JUSTIFICATION

REMOVAL OF INTERNAL CASEMENT WINDOWS

107 HIGH STREET, LINDFIELD, HAYWARDS HEATH, RH16 2HR

Proposed West Elevation

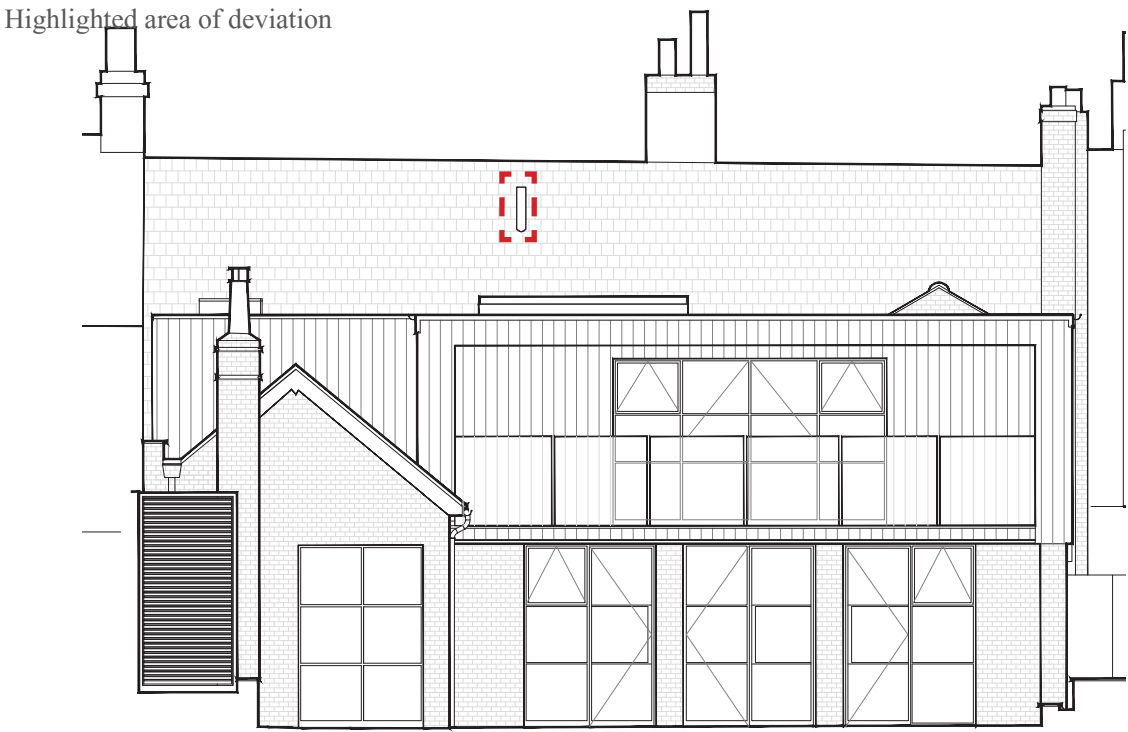
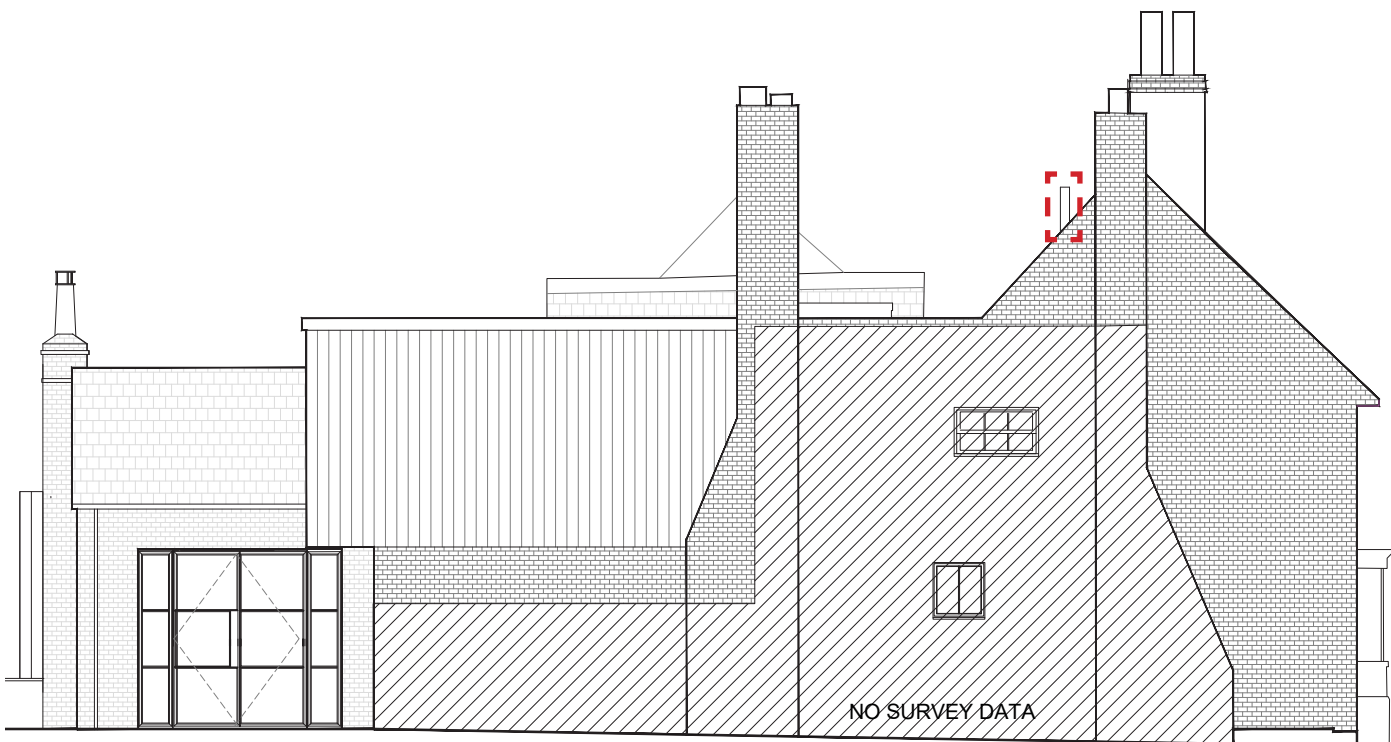
As can be seen from the drawings below, the position of the boiler flue on the rear sloping roof pitch is such that it is not visible from the principal elevation.

As-built ground floor plan

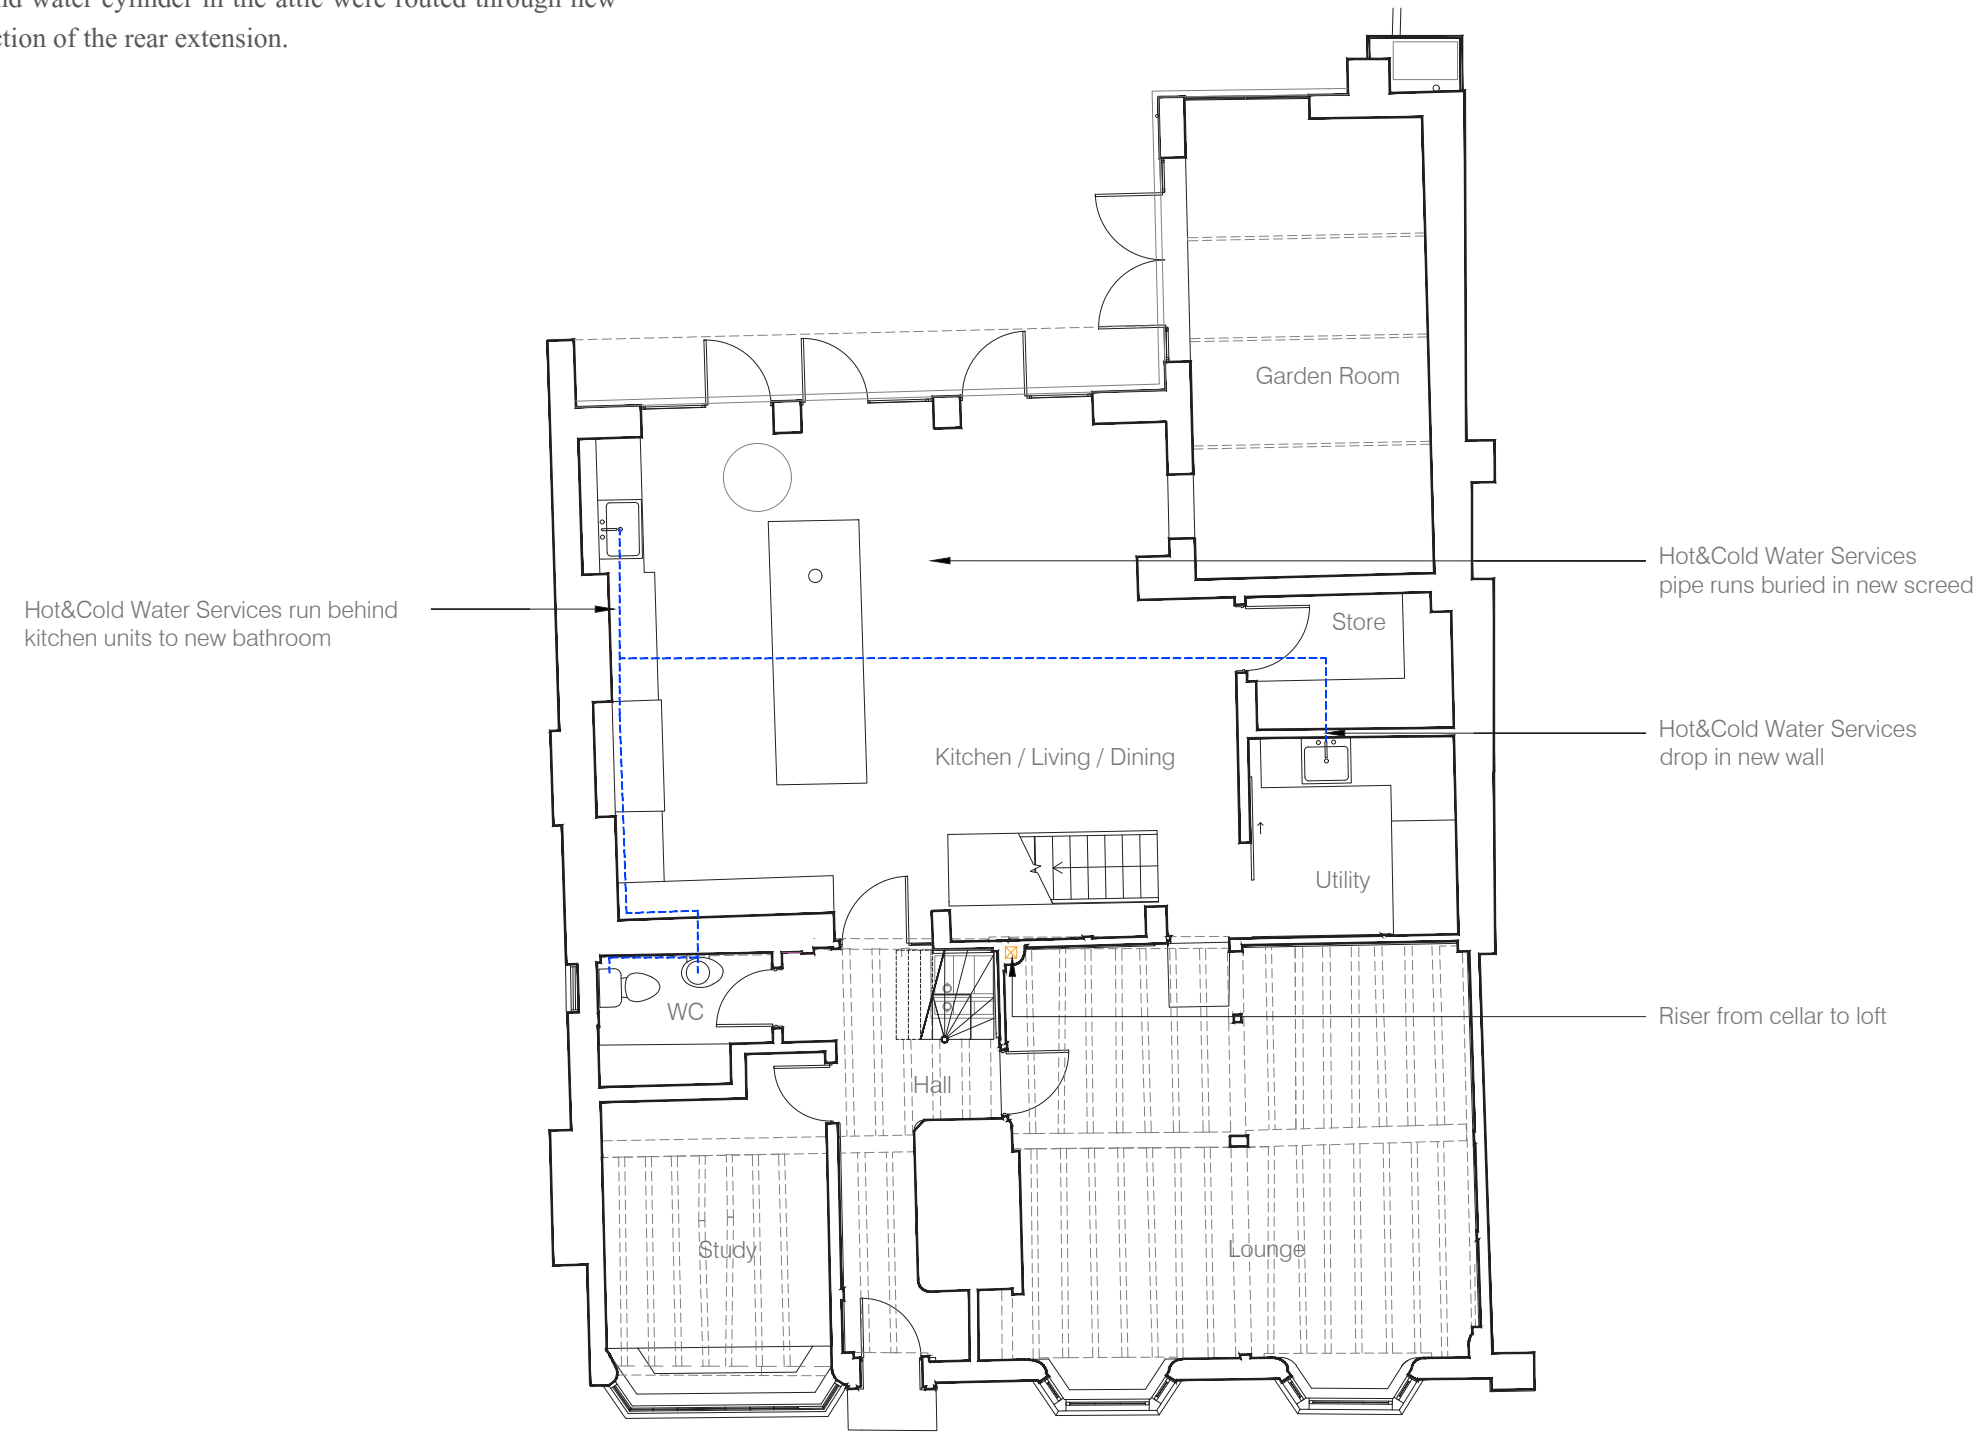
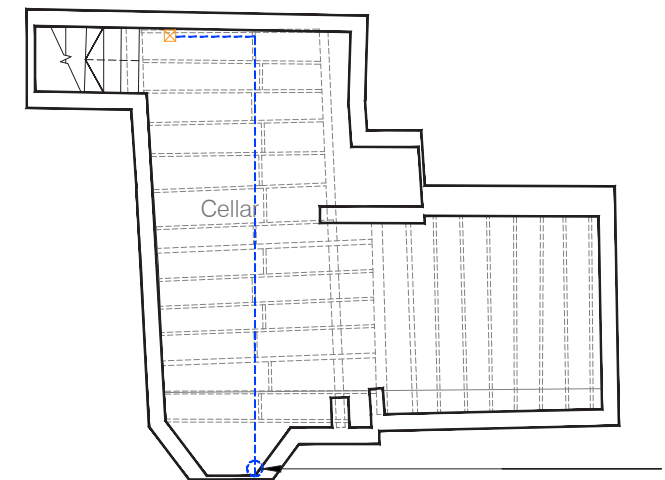
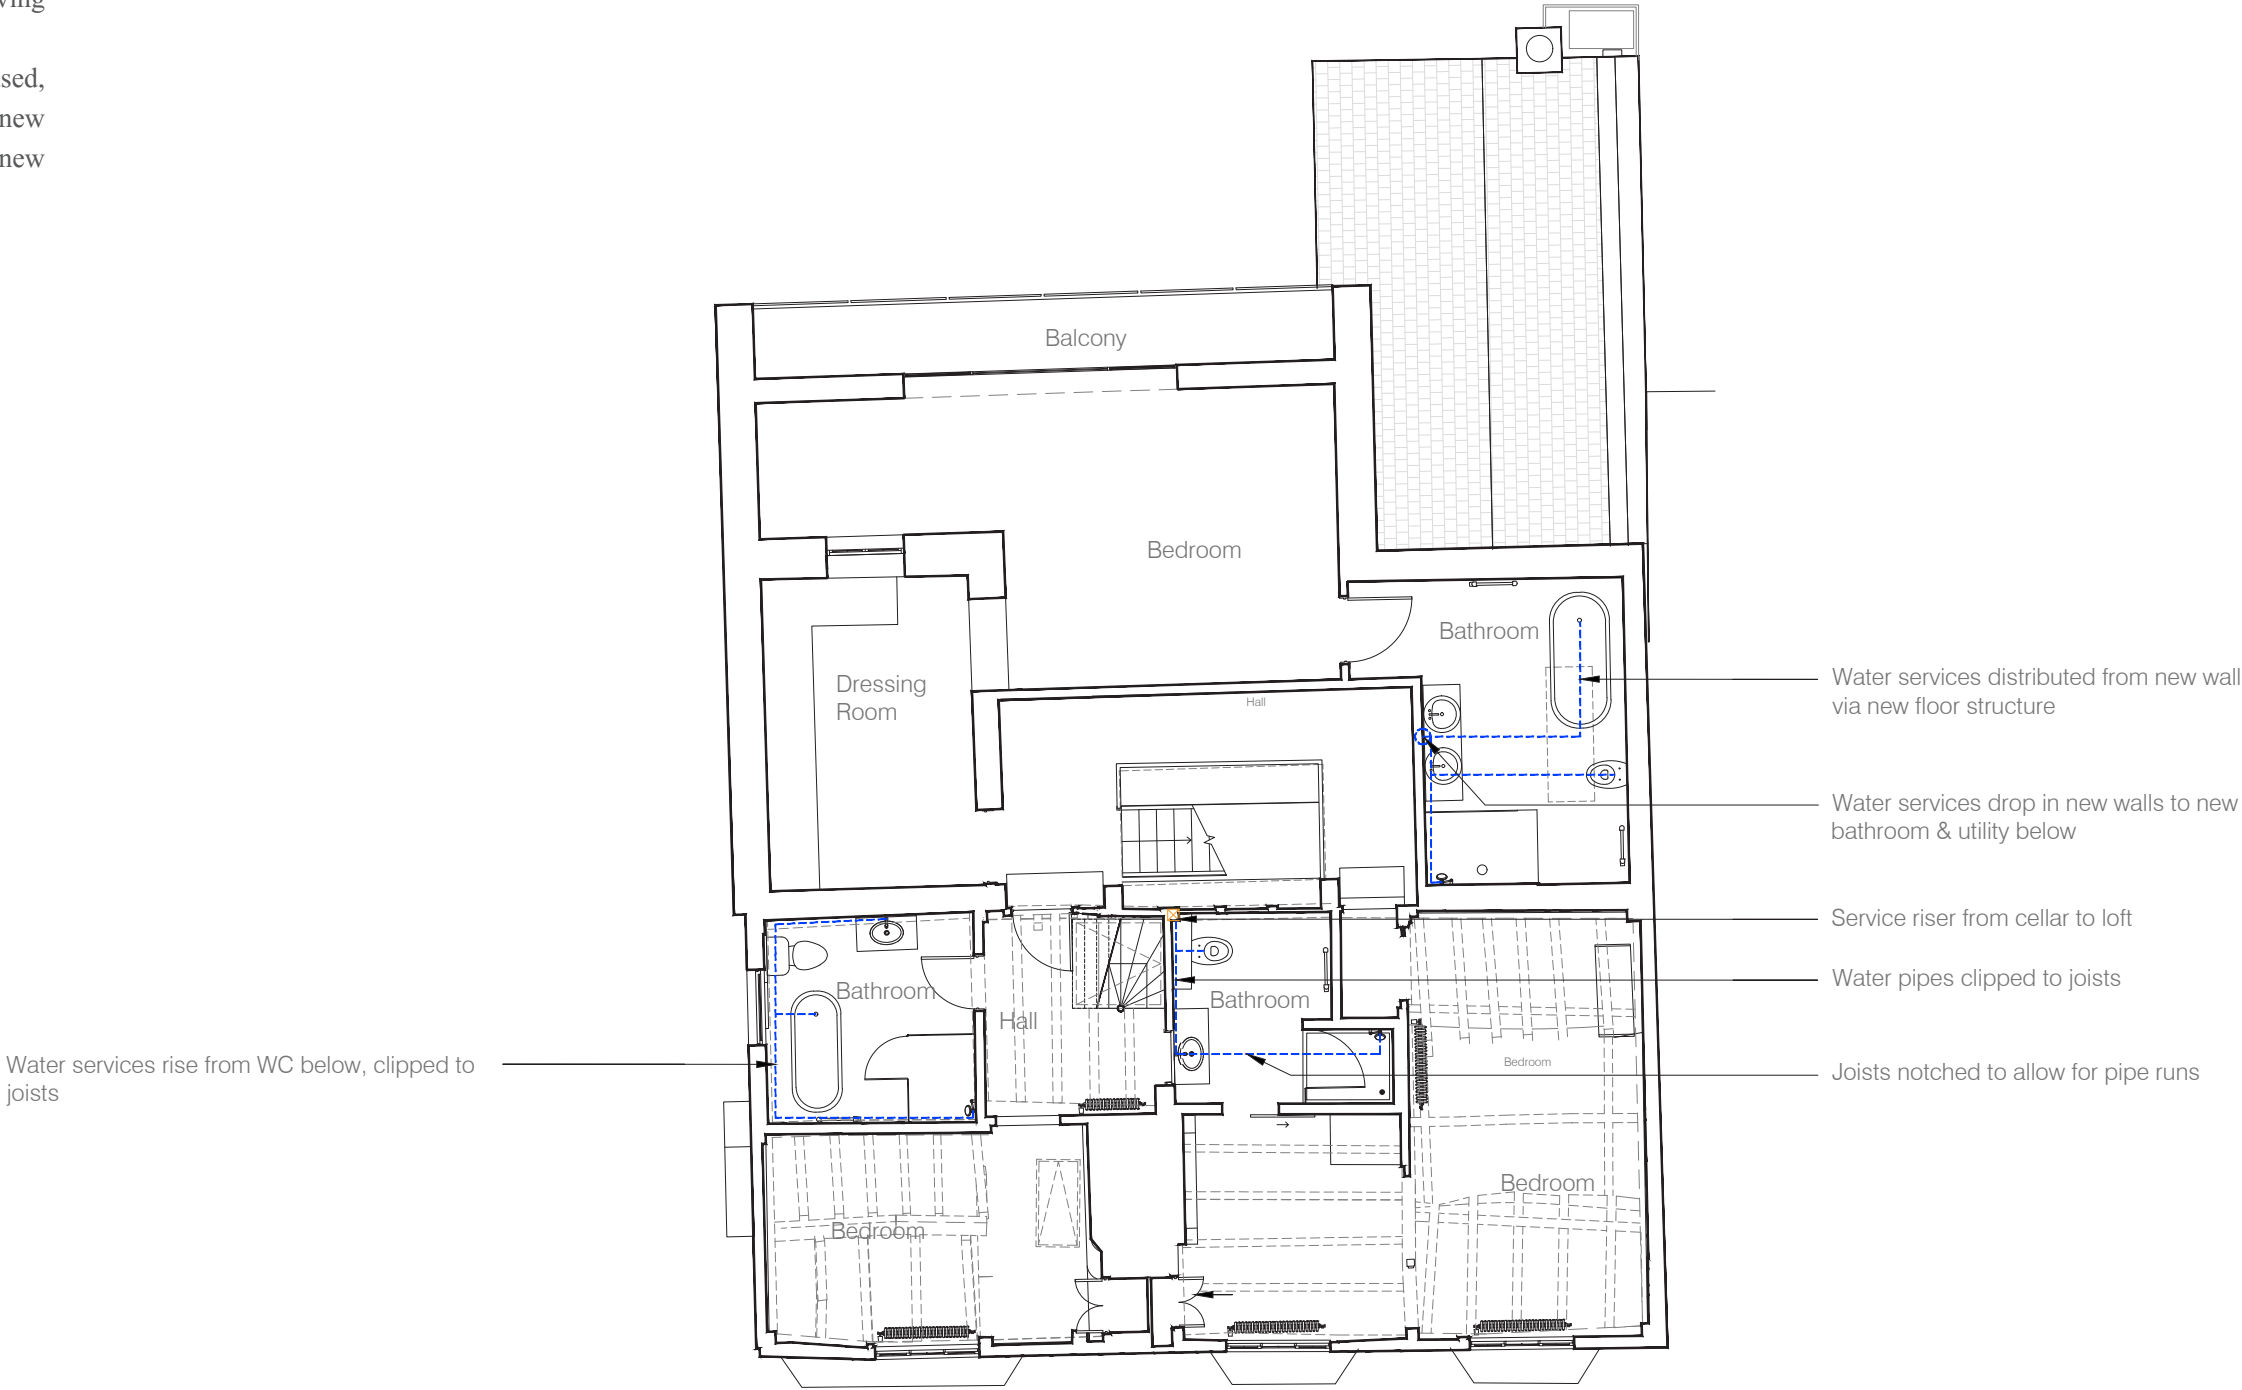
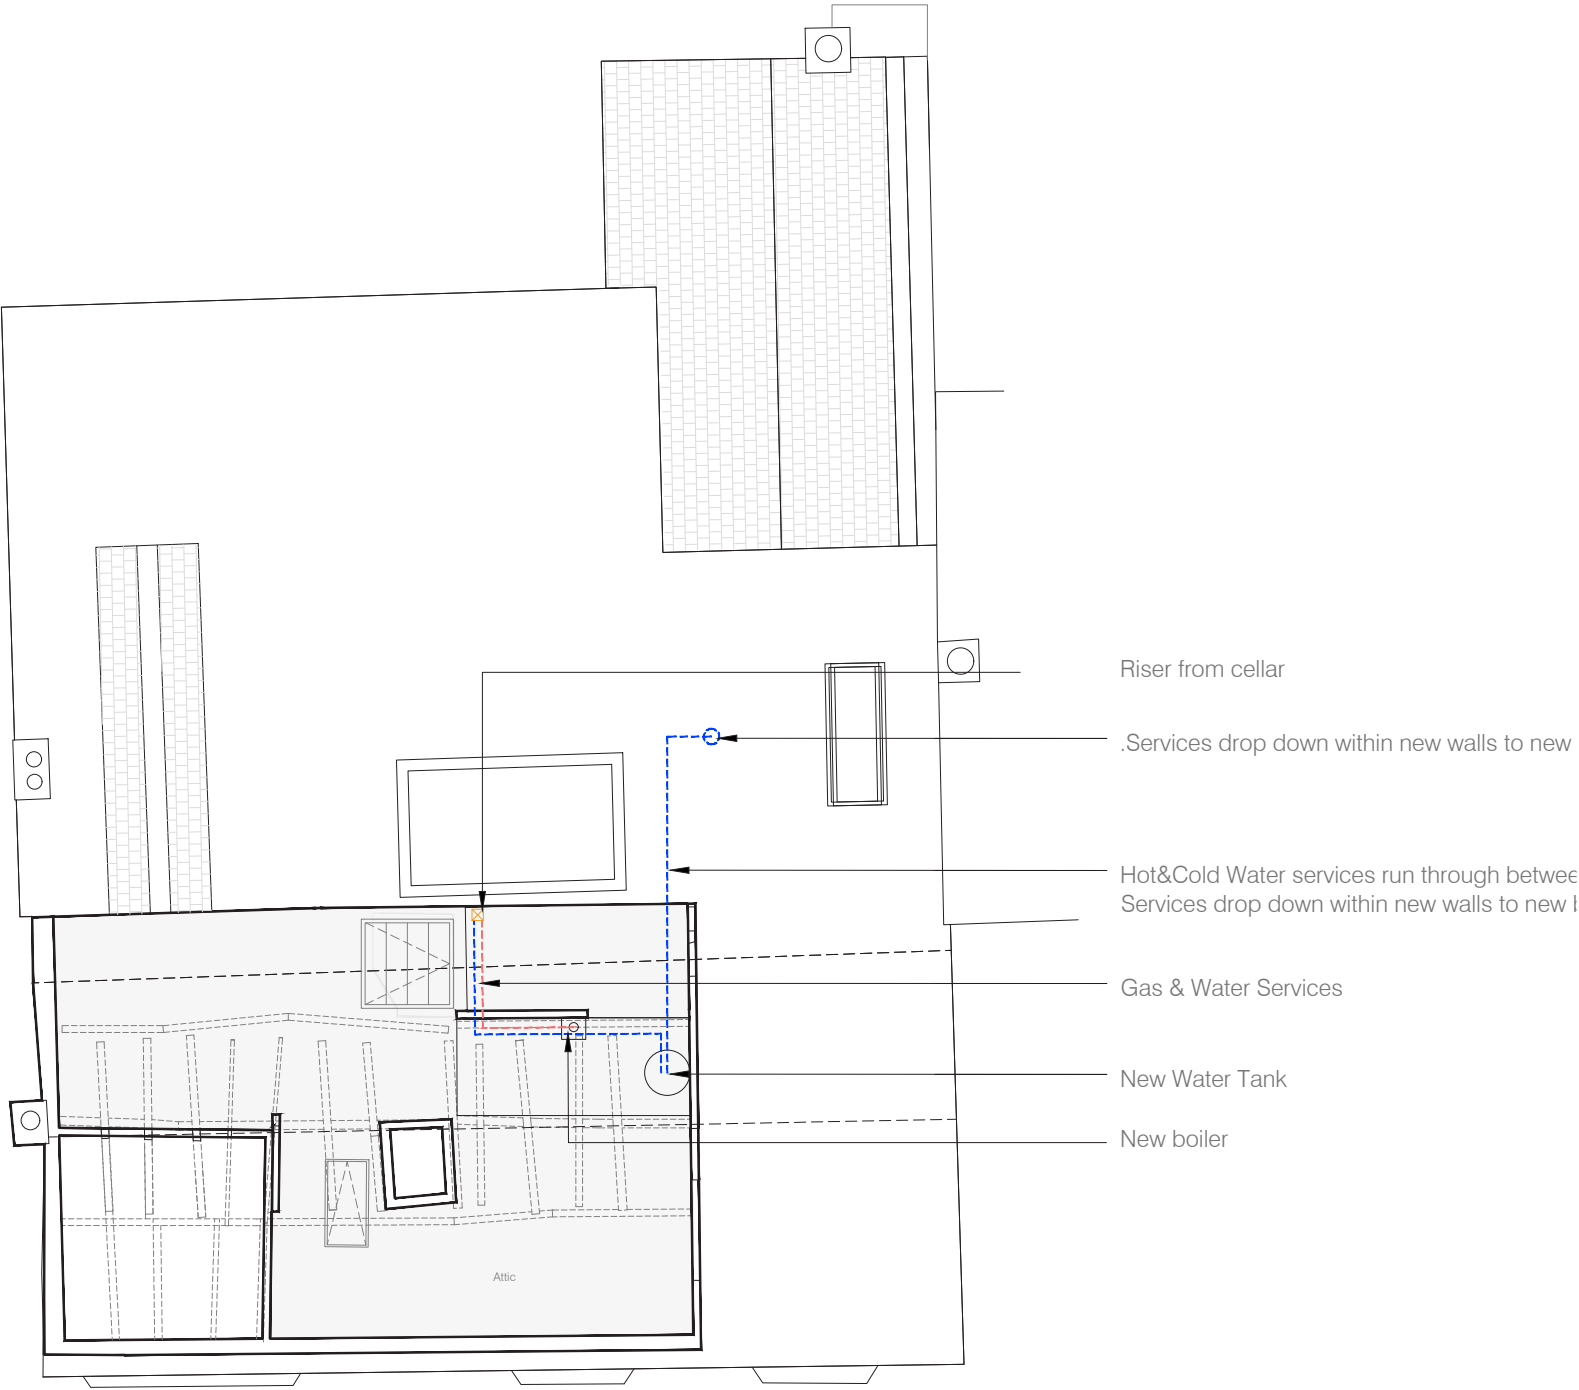
The adjacent diagram illustrates new water pipe runs serving the building.

Where possible existing house service routes were used, minimising impact on the existing building. Pipe runs to new boiler and water cylinder in the attic were routed through new construction of the rear extension.
